Hearing Examiner Staff Report and Recommendation

Report Date: June 2, 2021
Hearing Date: June 10, 2021

Project Name: El Dorado (Blue Fern) Preliminary Plat
Type of Application: PPLAT
Permit Number: 20-01380

Figure 4 Excerpt from Preliminary Plat Plans

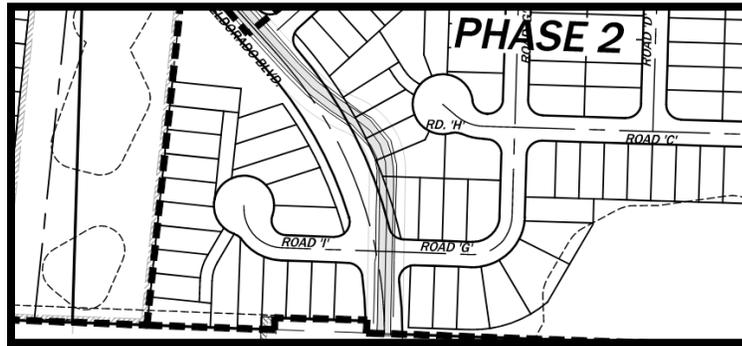
Proposed roads 'C' and 'J' do not align (See Figure 6); however, in coordination with Kitsap County Public Works Traffic Division, it was found that these road segments are adequately off-set and provide proper site distance consistent with the Kitsap County Road Standards.

Figure 5 Excerpt from Preliminary Plat Plans

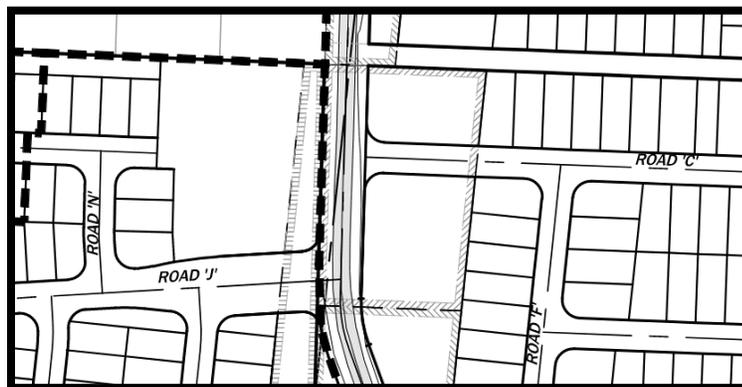
Staff Comment: *Eldorado Boulevard provides adequate north-south connectivity and is proposed to remain, with improvements. Proposed road 'A' aligns with NW Rydan Ct across Eldorado Blvd, meeting road connectivity requirements (See Figure 4). Proposed roads 'I' and 'G' align with each other, meeting connectivity requirements (See Figure 5).*

Figure 8 Revised Layout, Type-N Stream Buffer

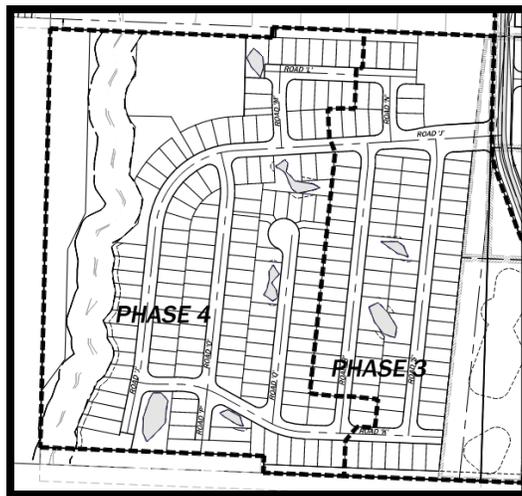
Following the County's notice of public hearing release, both the Tribe and WDFW informed the County that a closer look at the original conclusion was needed. On March 17, both WDFW and the Tribe met with the applicant representatives onsite. The same evening WDFW confirmed via email (Exhibit 71) that after further review the agency determined the observed watercourse met the characteristics of a Type N water. To accommodate this finding, the applicant revised their proposal to locate all proposed lots in Phase 4 outside of the 50-ft stream buffer required by KCC 19.300. Additional lots and roadways in proposed Phase 3 and 4 required modified layouts to accommodate the change.
